# UNITED STATES PATENT AND TRADEMARK OFFICE

APPLICATION NO.	FILING DATE	FIRST NAMED INVENTOR	ATTORNEY DOCKET NO.	CONFIRMATION NO.
10/675,520	09/30/2003	Henning Gold	JAA 216T2	6103

# Office Action Summary

### **DETAILED ACTION**

Fig. 8

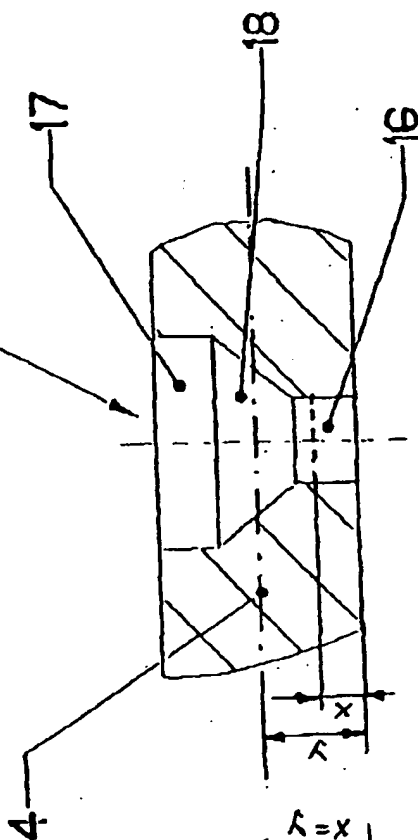
3. The drawings are objected to under 37 CFR 1.83(a). The drawings must show every feature of the invention specified in the claims. Therefore, the first, second, and third bore-holes as now claimed in claims 18-24 must be shown or the feature(s) canceled from the claim(s). No new matter should be entered.

Due to the numerical identification of the "bore-holes" it becomes unclear exactly what structure applicant considers to be the "first, second and third tapered bore-holes" in the drawings, although it appears these claims are directed to figures 3 or 8.
